ACCESSION NBR: 8403300058. DOC. DATE: 84/03/27 NOTARIZED: NO DOCKET #
 FACIL: 50-220 Nine Mile Point Nuclear Station, Unit 1, Niagara Powe. 05000220
 AUTH. NAME: AUTHOR AFFILIATION
 MANGAN, C. V. Niagara Mohawk Power Corp.
 RECIP. NAME: RECIPIENT AFFILIATION
 VASSALO, D. B. Operating Reactors Branch 2

SUBJECT: Forwards proposed mod. to existing logic for automatic initiation of diesel generators upon loss of voltage & degraded voltage. Proposed mod involves physical changes to undervoltage relaying circuits for Powerboards 102 & 103.

Modification of Bus Undervoltage Protective
Relaying Circuits for Powerboards 102 and 103

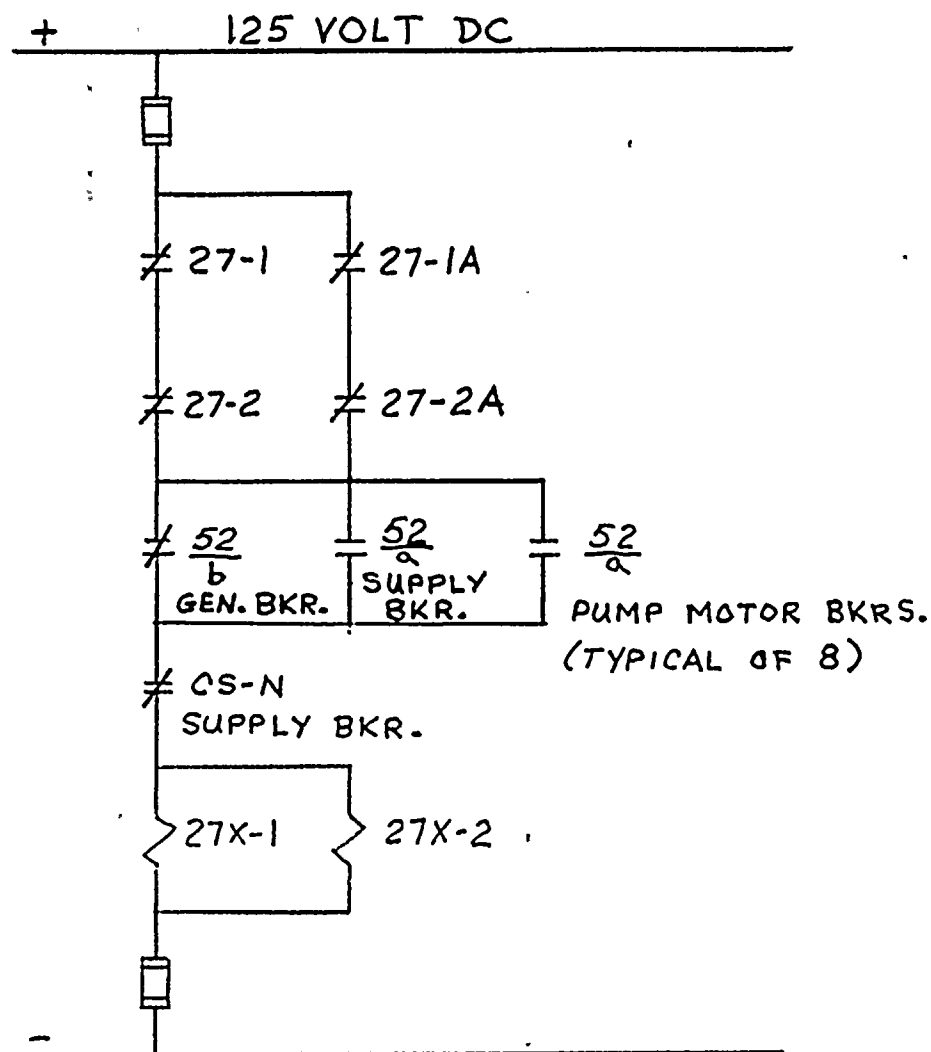
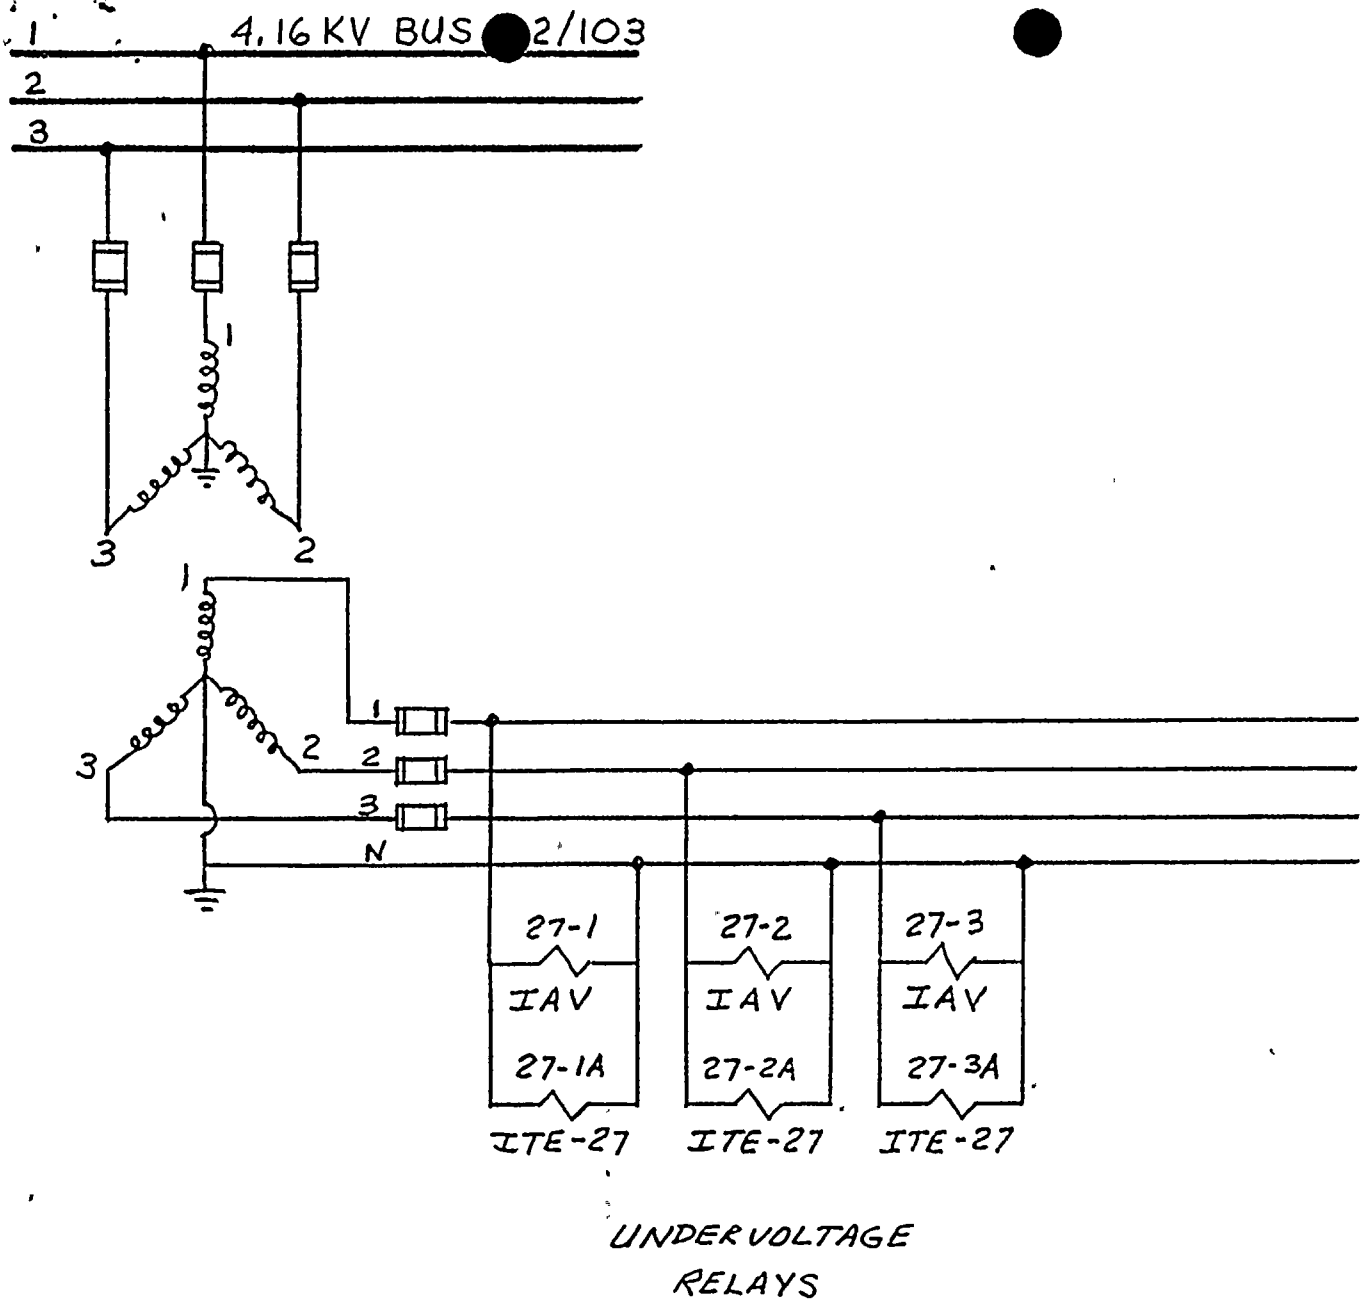
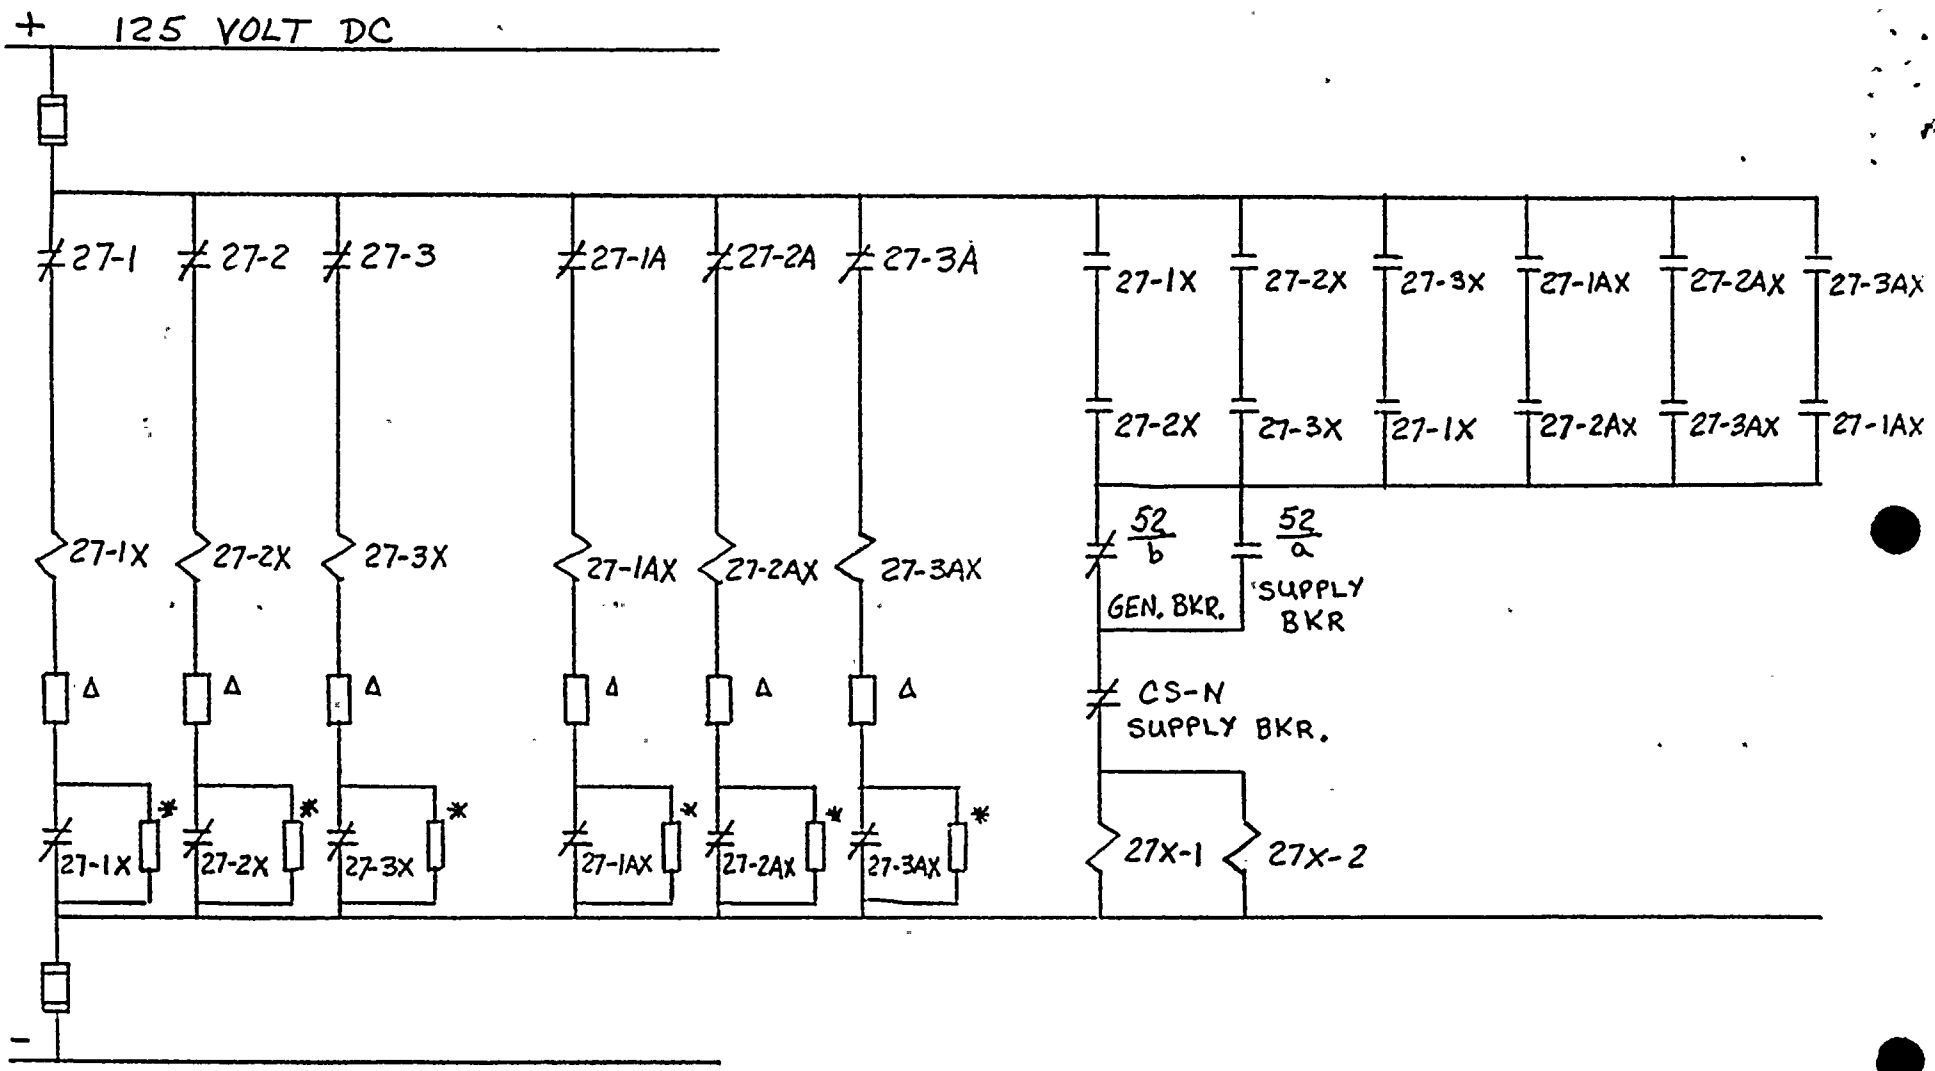
As presently designed, a deficiency exists in the undervoltage protective relaying circuits for Powerboards 102 and 103. With the present design, if an open occurs on phase 1 or 3, an alarm will operate. If an open occurs on phase 2, the undervoltage relays would initiate a transfer to on site power. A problem arises if the open on phase 2 is in the bus or in the potential transformer primary such as a blown fuse or an open primary winding. This condition would not allow the undervoltage relays to reset when the bus is reenergized from the diesel generator. Each of the safeguard pump motor breakers will continue to close and trip as soon as its timer initiates the first closure.

The purpose of this modification is to design and install an undervoltage protective relaying scheme that will alarm for an open phase condition on phases 1, 2, or 3. This scheme would protect against possible damage to safeguard equipment (such as core spray and containment spray pump motors) as a result of breakers tripping and closing.

The modified undervoltage relaying circuits will monitor phase-to-neutral voltage on all three phases instead of phase-to-phase voltage on two phases. The logic for initiation of transfer and load shedding would be changed from a two-out-of-two to a two-out-of-three circuit for both the loss-of-voltage and degraded system monitoring relays. To initiate a transfer to on site diesel generator power and to initiate the emergency powerboard's load shedding feature, the following conditions must be satisfied: the control switch for power circuit breaker (R1012/R1013) must be in the normal (after closed) position, a loss of voltage or degraded system condition must exist of emergency Powerboard 102/103 and one of the following:

1. the power circuit breaker (R1012/R1013) located near Powerboard 101 feeding off site power to the emergency Powerboard 102/103 must be closed, or
2. the diesel generator output power circuit breaker must be open.

Changing the conditions required to initiate transfer and load shedding will ensure that these features are disabled when the emergency powerboards are connected to the on site diesel generator and are enabled when the diesel generator output power circuit breaker is open. This will ensure that the protective relaying scheme is in compliance with paragraphs 5.1.5.2 and 5.1.5.3 of proposed IEEE Standard P741, "Standard on Protection of Class 1E Power Systems and Equipment." In addition, this design will meet the design criteria as outlined in Staff Position 2 of the June 2, 1977 Nuclear Regulatory Commission's correspondence.
